# SERVICE BULLETIN NO. 16

SEC. VIII, DIV. A  
SERVICE BULLETINS  
ISSUED SEPTEMBER, 1963

FIG. 2

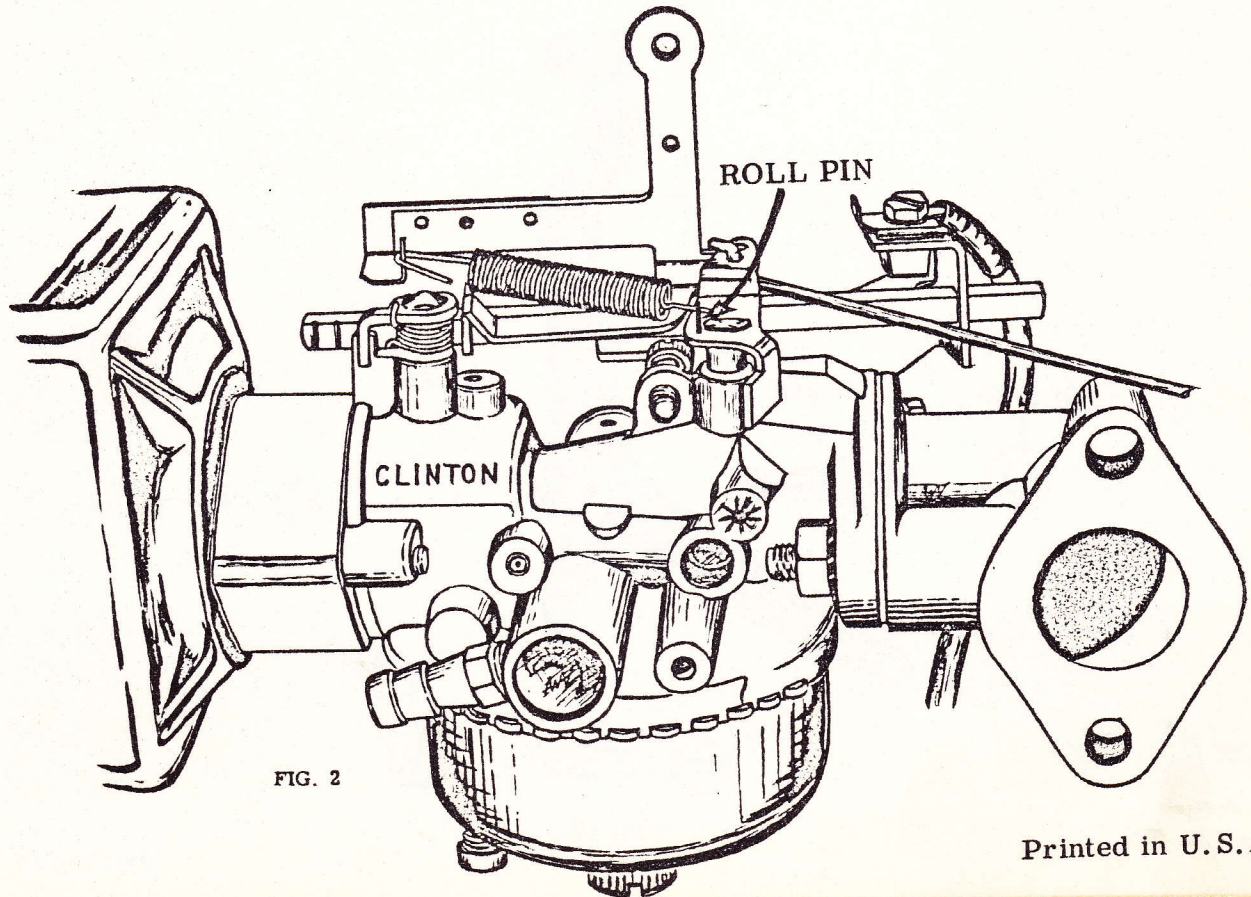
A Field Fix has been designed to eliminate a surging condition found on some Vertical Shaft engines.

A replacement Throttle Shaft & Lever Assembly, Part No. 6-441-500, which incorporates a Roll Pin to stabilize the Governor during the entire operating range should be used in place of 6-108-500. This Shaft & Lever is used on the following:

Proper Spring installation (as illustrated) is important.
